GROUP Safety Recall Campaign	MODEL 2017-2021MY Sportage (QL) & 2017-2019MY Cadenza (YG)
NUMBER SC206	DATE March 2021

SUBJECT: NEW FUSE KIT INSTALLATION IN JUNCTION BOX (SC206)

This bulletin provides the procedure to install a new fuse kit for the Hydraulic Electronic Control Unit (HECU) in the junction box on some Sportage (QL) and Cadenza (YG) vehicles listed in the table below. Also, affected Sportage (QL) vehicles equipped with the Electronic Parking Brake (EPB) will also get the HECU software logic update. The affected vehicles may exhibit numerous warnings, including illumination of the tire pressure warning light, ABS warning light, MIL warning light, a burning/melting smell and/or smoke from engine compartment in the area where the HECU is located. It is believed that the electrical circuit within the HECU experiences a short circuit condition that results in excessive current, thereby increasing the risk of an engine compartment fire. Before conducting the procedure, verify that the vehicle is included in the list of affected VINs.

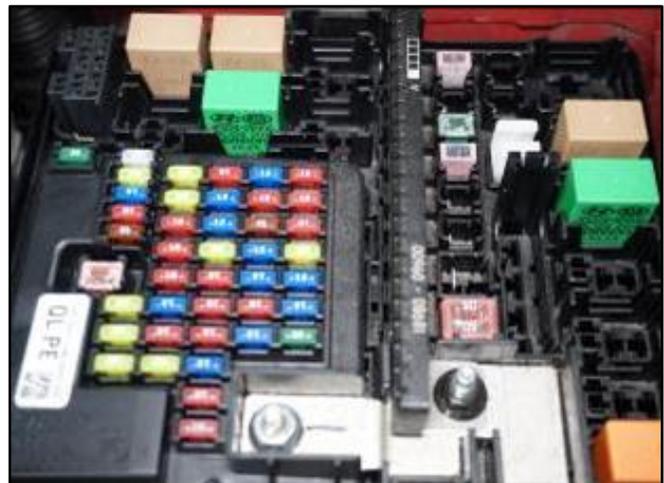
1. Disconnect the negative (-) battery terminal and open the junction box cover.

2. Remove the following two (2) fuses from the junction box:

1. ABS1
2. ABS2

3. Install the new required two (2) new 30A fuses.

Applicable Fuses	
(QL) NO EPB (30A)
